# UNITED STATES PATENT AND TRADEMARK OFFICE

## Office Action Summary

10/596,039

## **DETAILED ACTION**

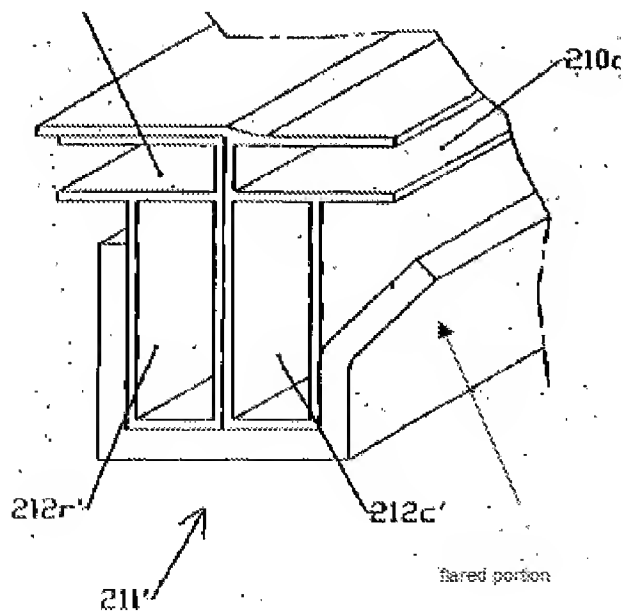
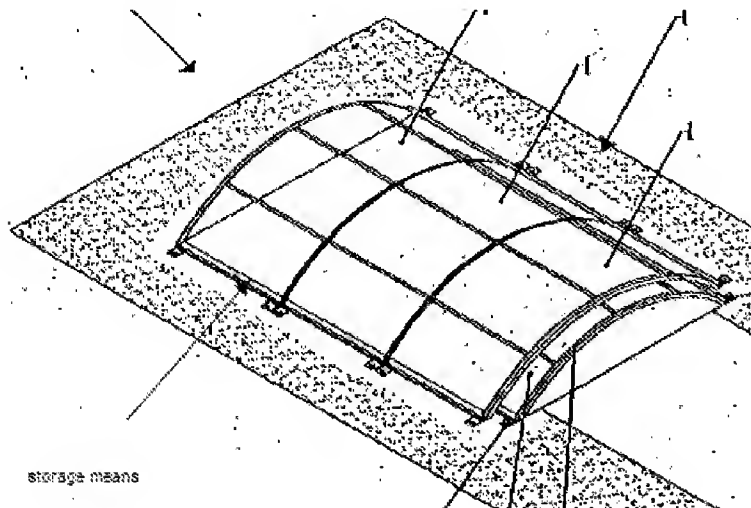
24. Regarding claims 11 - 14, Chapus shows a connection means, having arches with wings (210) which extend over the panels and permit sealed covering of the roof components (see fig. 8a). The connection means also allows the roof components to be articulated relative to the support edge of the pool (fig. 2), as the connection means are dissociable from one another in a vertical direction. There is a U-shaped profile (211) which conforms to the shape of the rectangular lower profiles of the arches and is

'fastened,' such that the rectangular profiles are housed and inserted into the U-shaped profile (see fig. 8a and 8b). There is finally a flared edge (see annotate figure) of the U-shaped profile, which allows 'play' of the arch when the roof component is in a juxtaposed position.
